RE: Willow Pass Generating Station
Application for Certification 08-AFC-6

Responses to CEC Data Requests (#58-61, 70, and 72)

Application for Certification (08-AFC-6) for **WILLOW PASS GENERATING STATION** Pittsburg, California

Figure 58-1

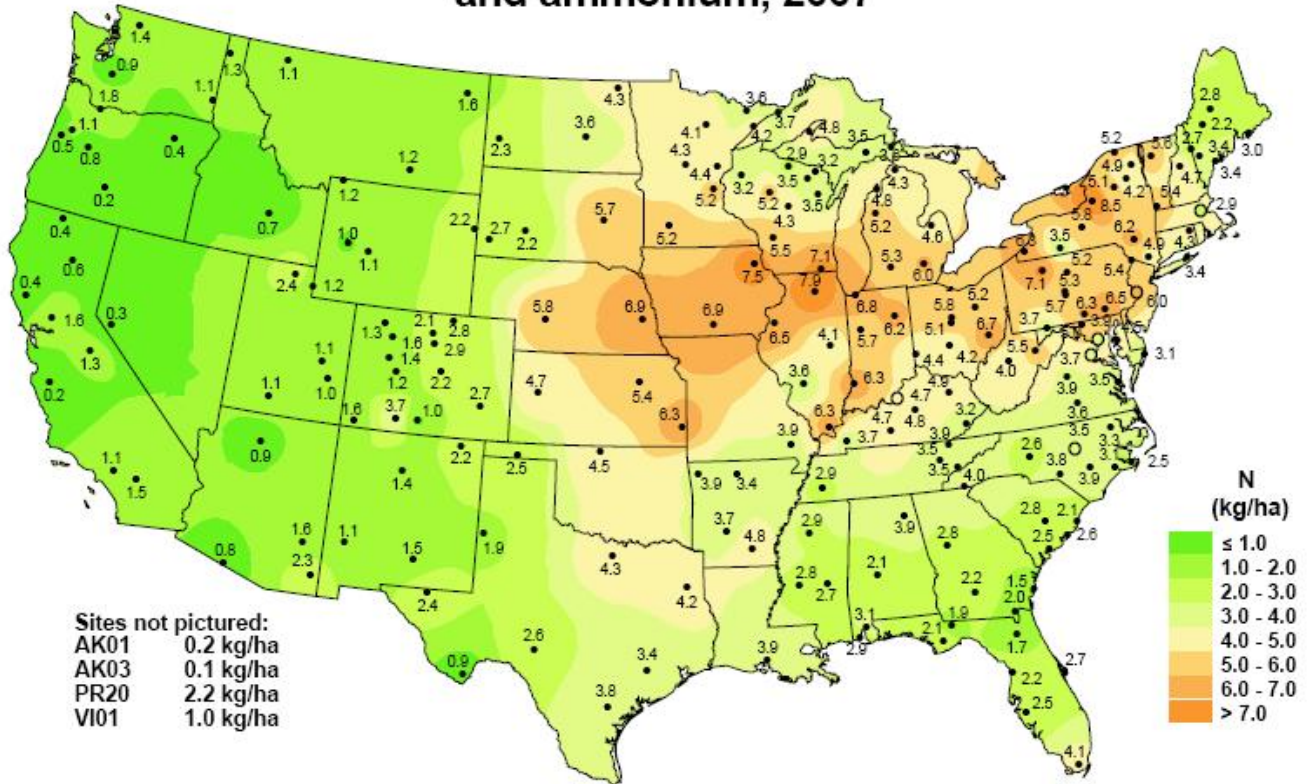
58. *Please quantify the existing baseline total nitrogen deposition rate in the vicinity of WPGS (encompassing the areas listed in DR #2) in kilograms per hectare per year (kg/ha/yr). Provide the complete citation for references used in determining this number.*

Based on data from the National Atmospheric Deposition Program, National Trends Network at The University of Illinois Urbana-Champaign (NADP, 2007), the wet nitrogen deposition rate in the vicinity of the Willow Pass Generating Station (WPGS), including the Antioch Dunes National Wildlife Refuge (NWR), was approximately 1.6 kilograms per hectare per year (kg/ha/yr) in 2007. Wet nitrogen deposition is used as a proxy for total nitrogen deposition because dry deposition rates are generally low and monitoring techniques for dry deposition are less reliable (RMNP, 2006). Figure 58-1 shows wet measured nitrogen deposition values across the country from the National Atmospheric Deposition Program. The background value of 1.6 kg/ha/yr is based on actual measured data from a deposition monitoring station in Davis, California, operated by the U.S. Geological Survey and the University of California-Davis.

FIGURE 60-1a

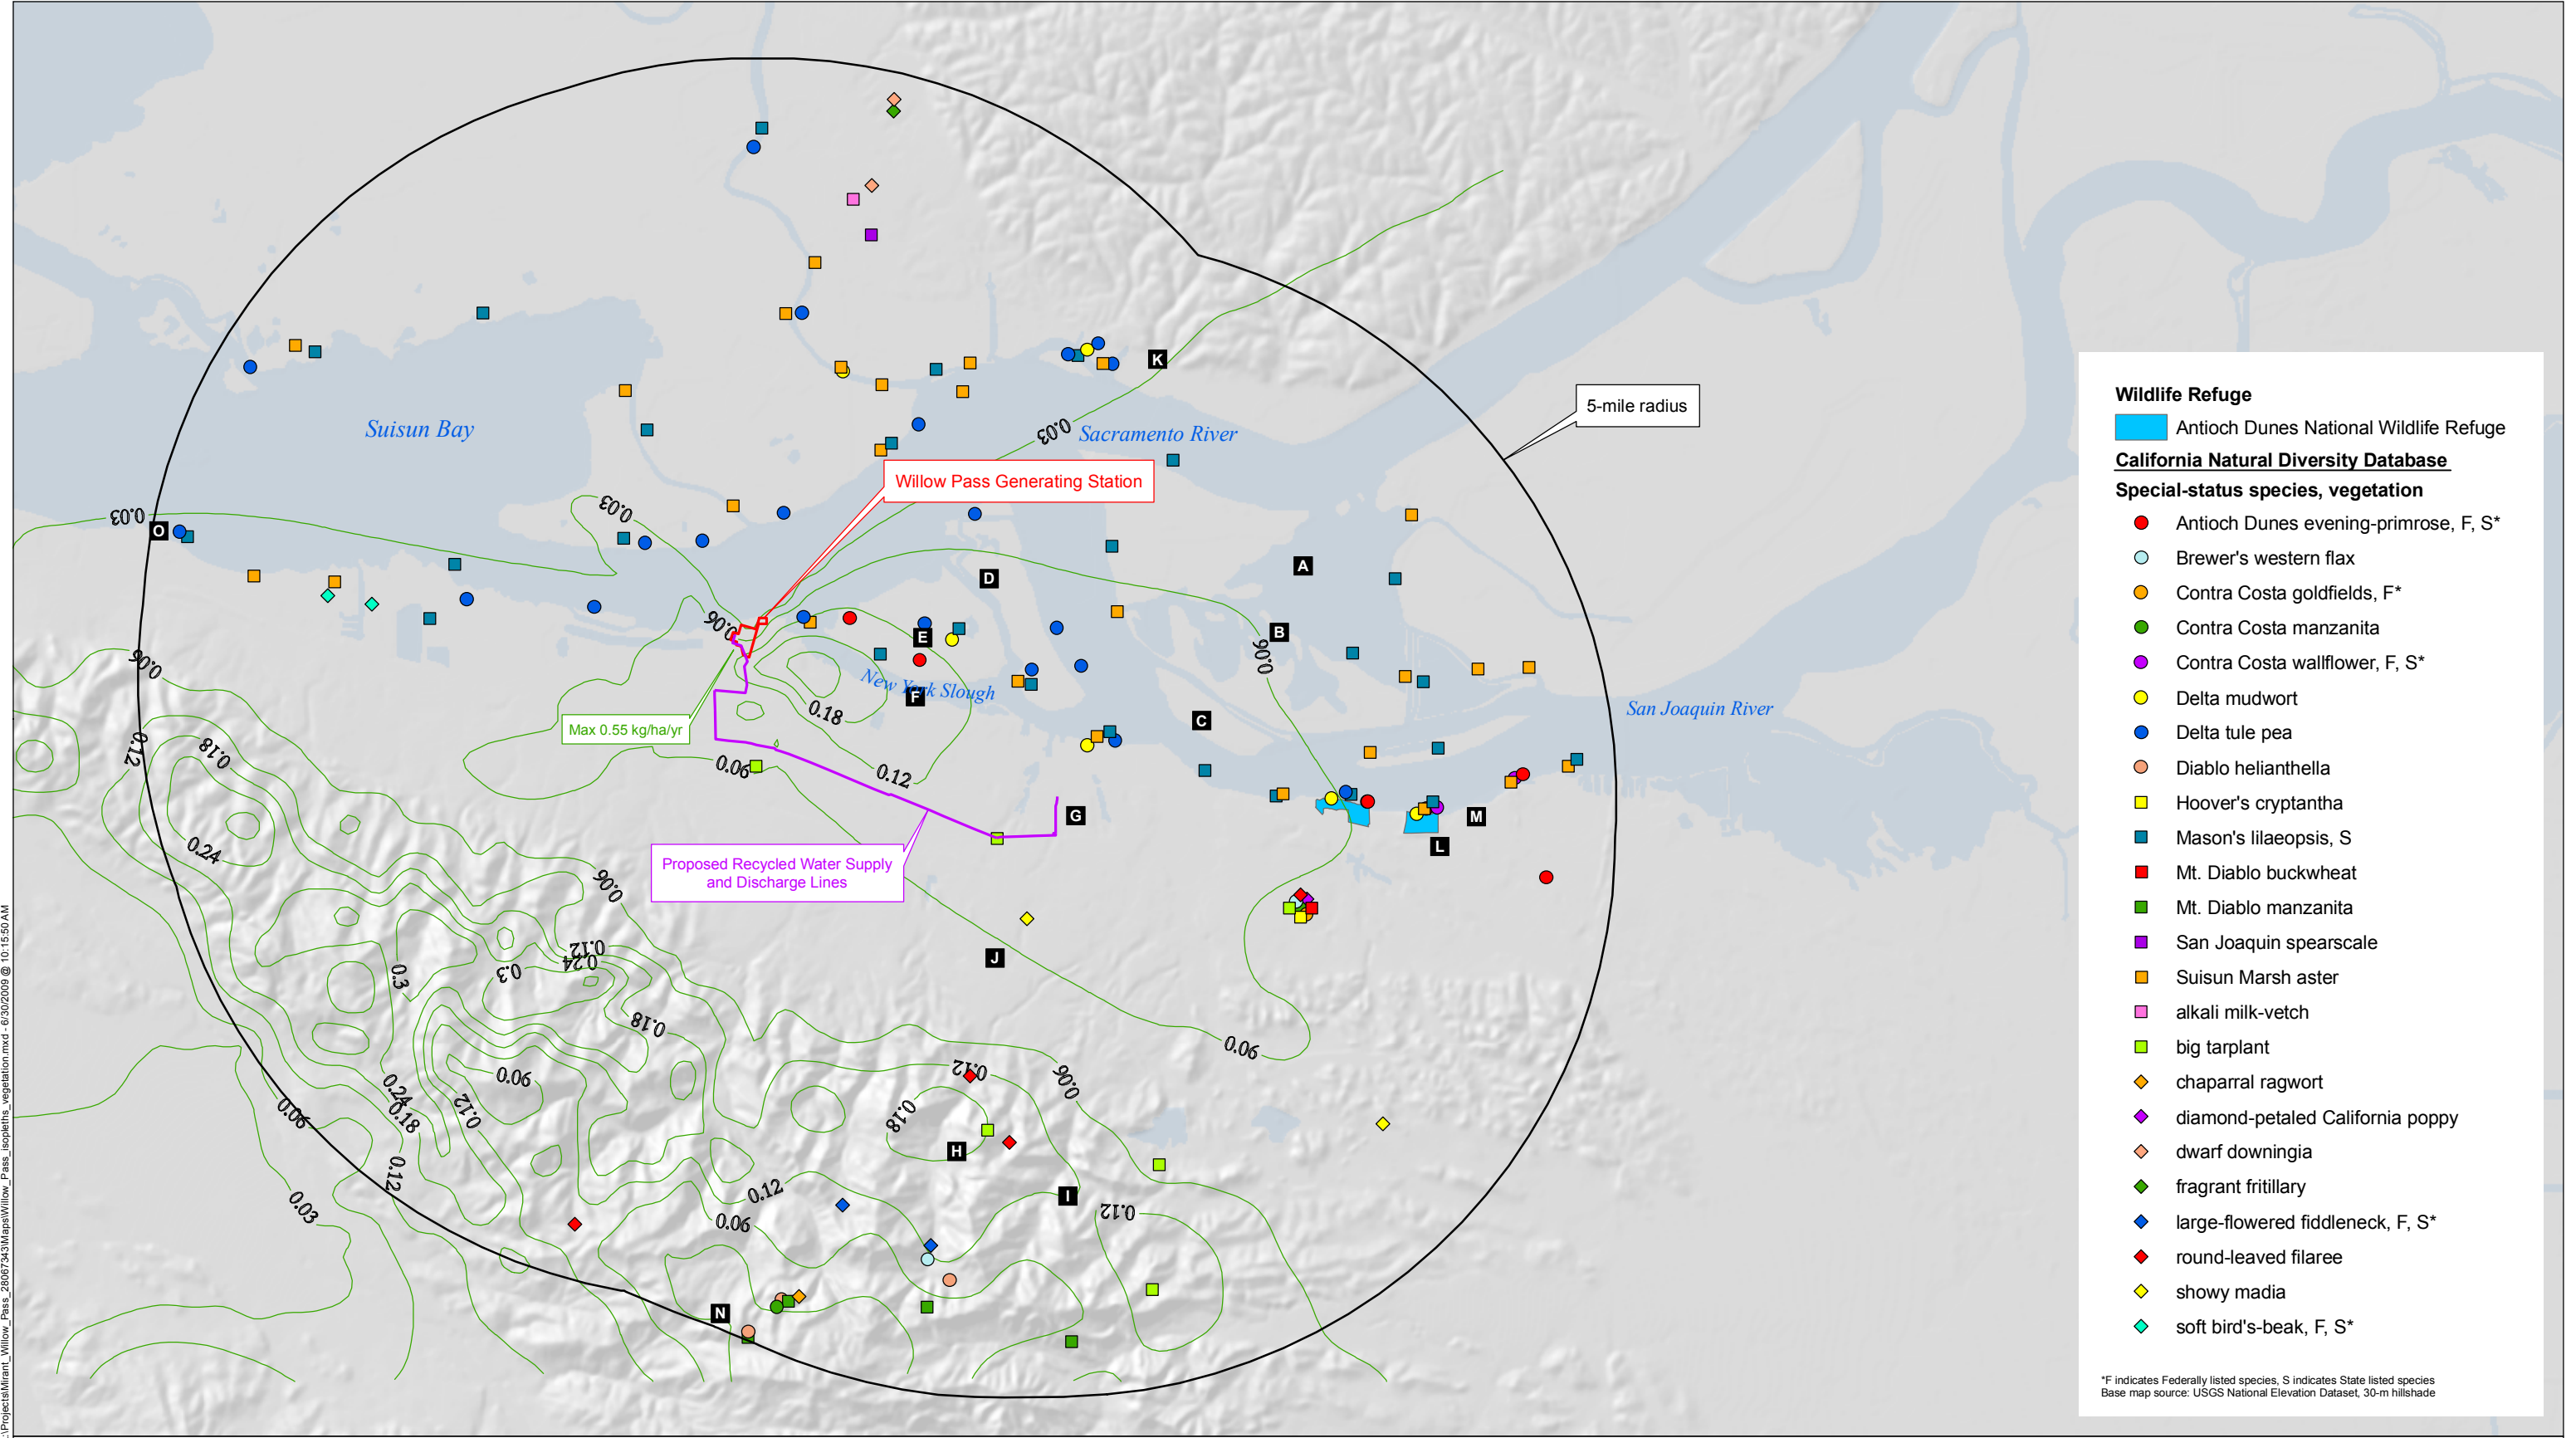
- 60. Please provide an isopleth graphic over USGS 7.5-minute maps (or equally detailed map) of the direct nitrogen deposition rates caused by the project that graphically depicts the results.**

As illustrated in Figures 60-1a and 60-1b, nitrogen deposition rates from WPGS at the Sardis Unit and Stamms Unit of the Antioch Dunes NWR are approximately 0.06 kg/ha/yr. With background, the maximum nitrogen deposition rate for the Antioch Dunes Wildlife Refuge is 1.66 kg/ha/yr.

Figures 60-1a and 60-1b provide the isopleths for nitrogen deposition rates due to the proposed project. Figure 60-1a shows the federal and state listed special-status vegetation species. Figure 60-1b shows the federal and state listed wildlife special-status species.

FIGURE 61-1a

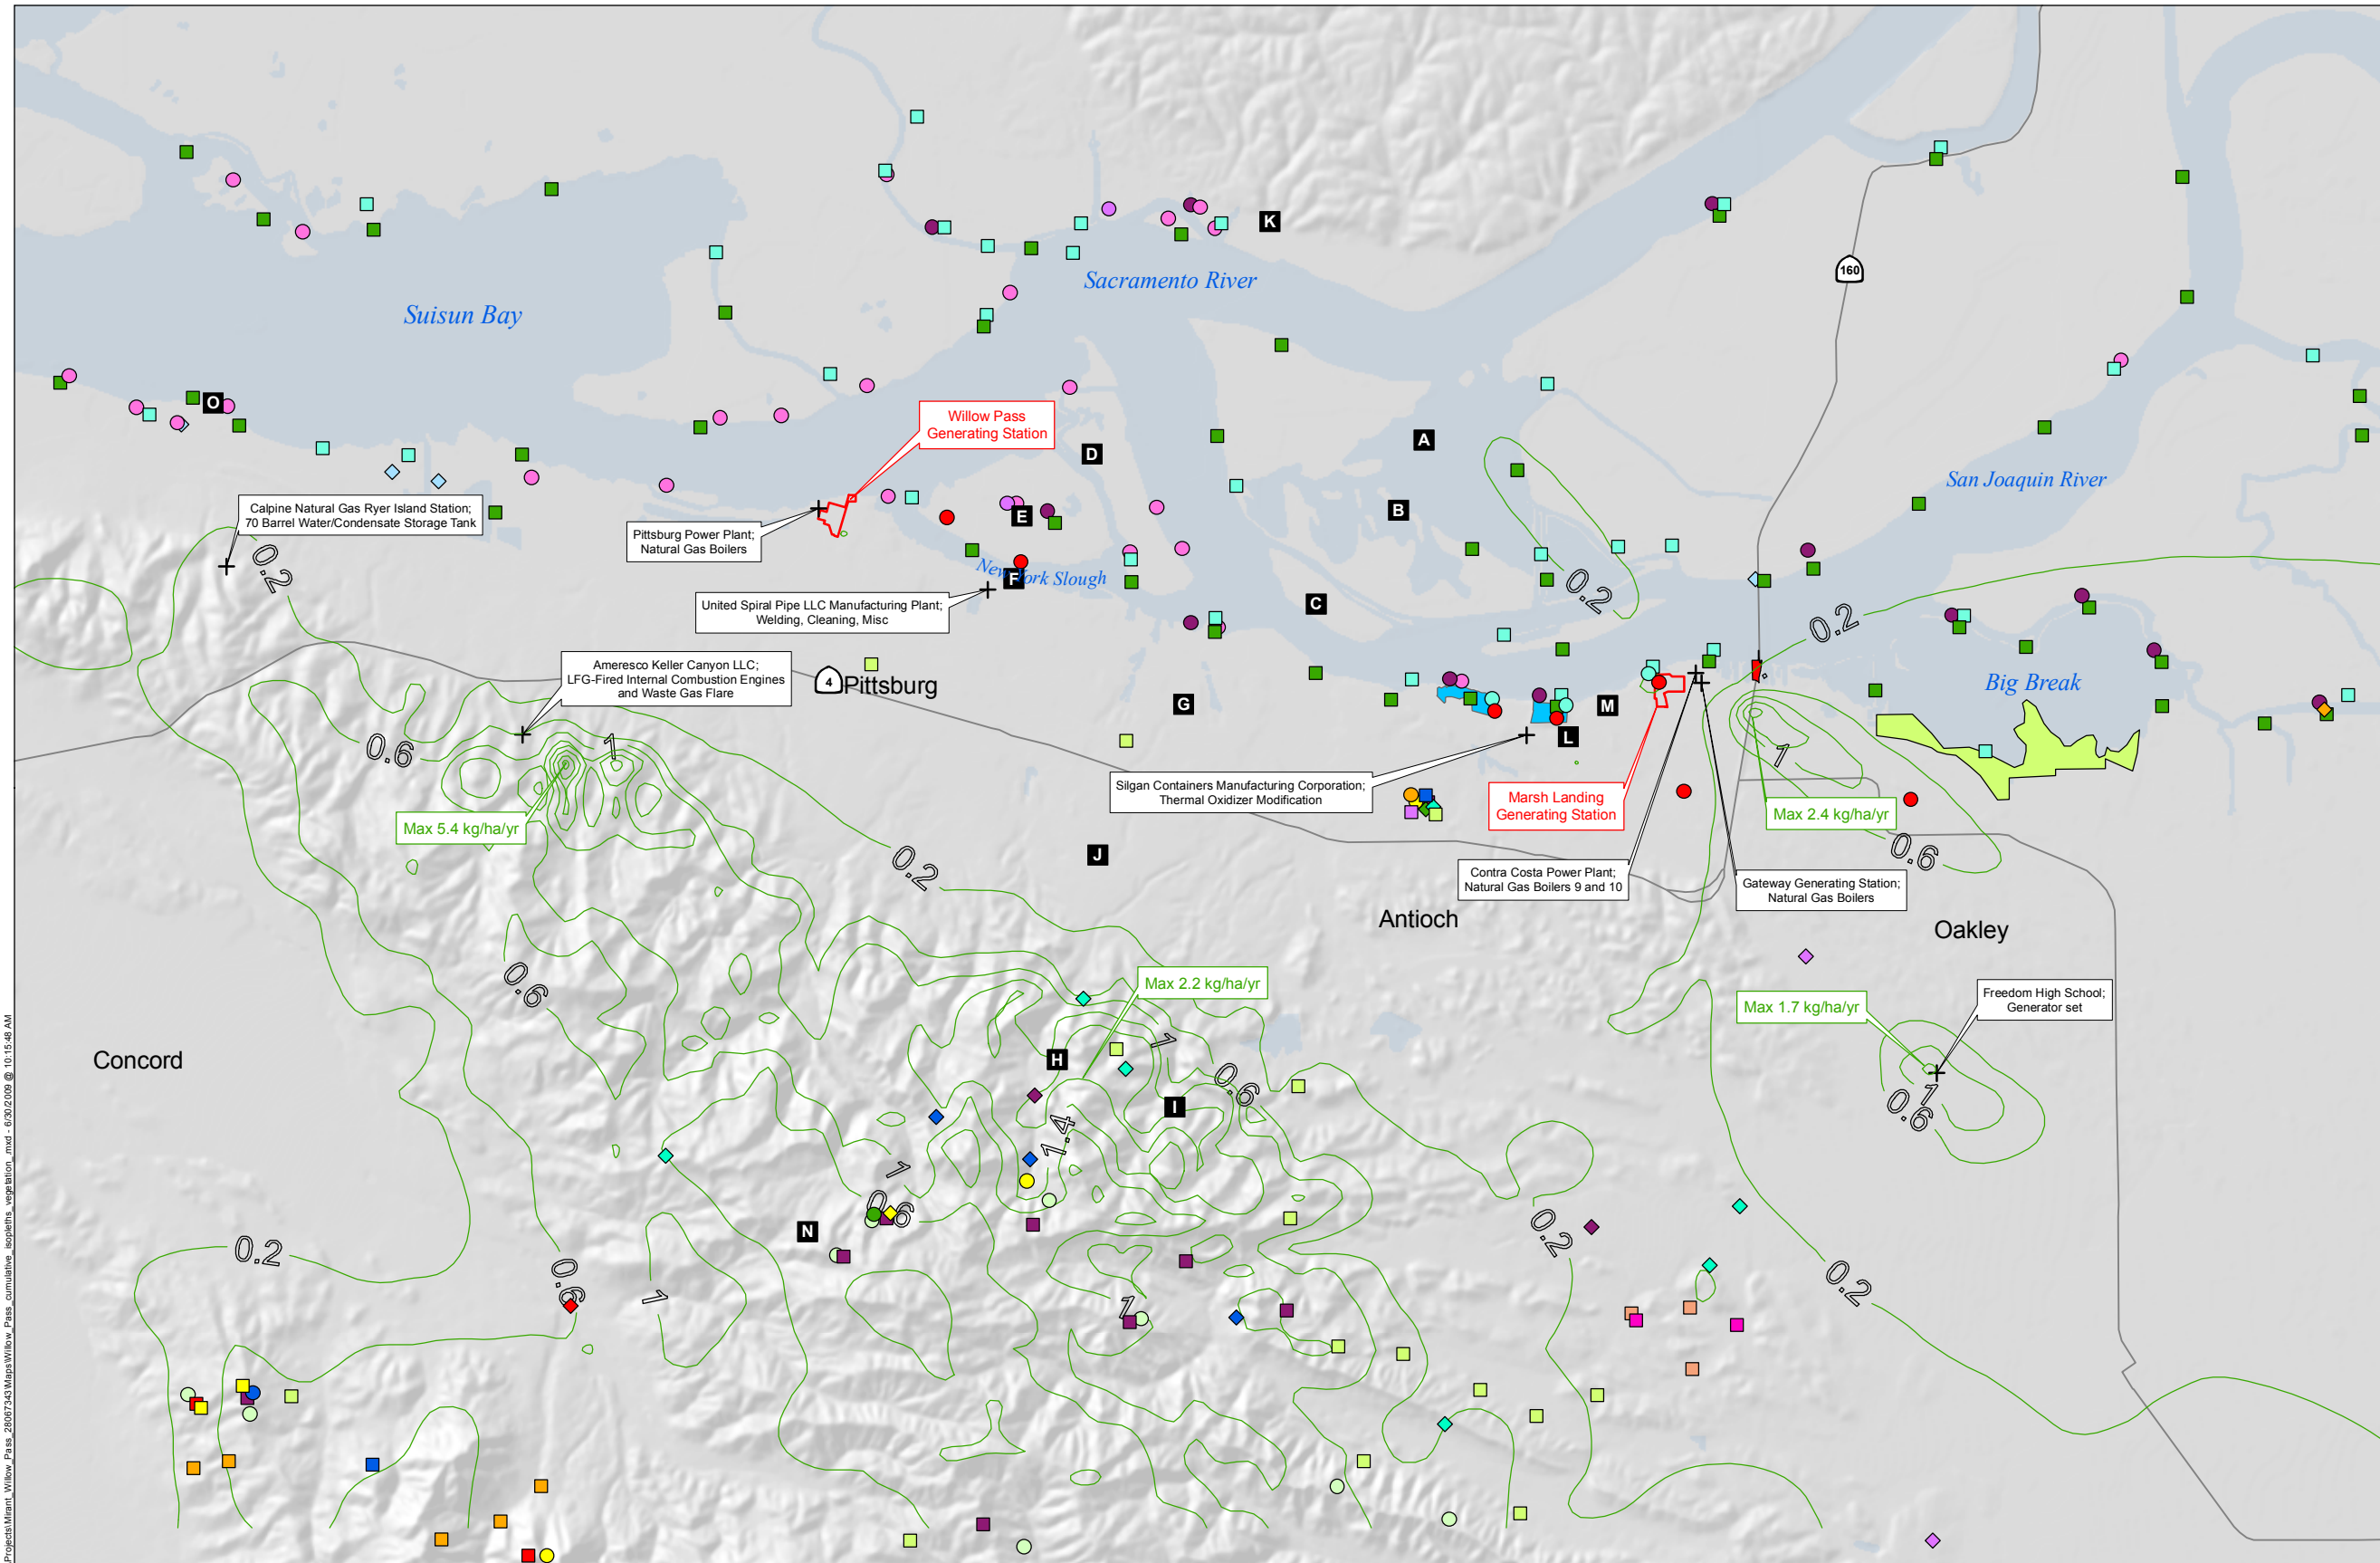
61. Please update the cumulative impact analysis (Tables 57-1 and 57-2) in Responses to Data Request Addendum Set #1A – Data Request #57 with nitrogen deposition values in kg/ha/yr. Provide an isopleth graphic over USGS 7.5-minute maps (or equally detailed map) of the direct nitrogen deposition values in the cumulative analysis.

Figures 61-1a and 61-1b provide the isopleths for nitrogen deposition rates in kg/ha/yr due to all cumulative sources listed in Table 61-1. Figure 61-1a shows the federal and state listed special-status vegetation species. Figure 61-1b shows the federal and state listed special-status wildlife species.

As seen in Figures 61-1a and 61-1b, the maximum cumulative nitrogen deposition value occurs in the hills south of Pittsburg, which is located approximately 3 miles southwest of the WPGS project site. The maximum nitrogen deposition rate for all cumulative sources is estimated to be 5.4 kg/ha/yr (without background) near the Ameresco Keller Canyon facility. This is the only area that would exceed the benchmark of 5 kg/ha/yr with background; however this area is not considered sensitive to nitrogen deposition since sands or serpentine soils are not known to be present. Approximately 98 percent of the highest nitrogen deposition rates in these hills are caused by nitrous oxide emissions from sources at the Ameresco Keller Canyon LLC facility, which includes two landfill gas-fired internal combustion engines and a waste gas flare.
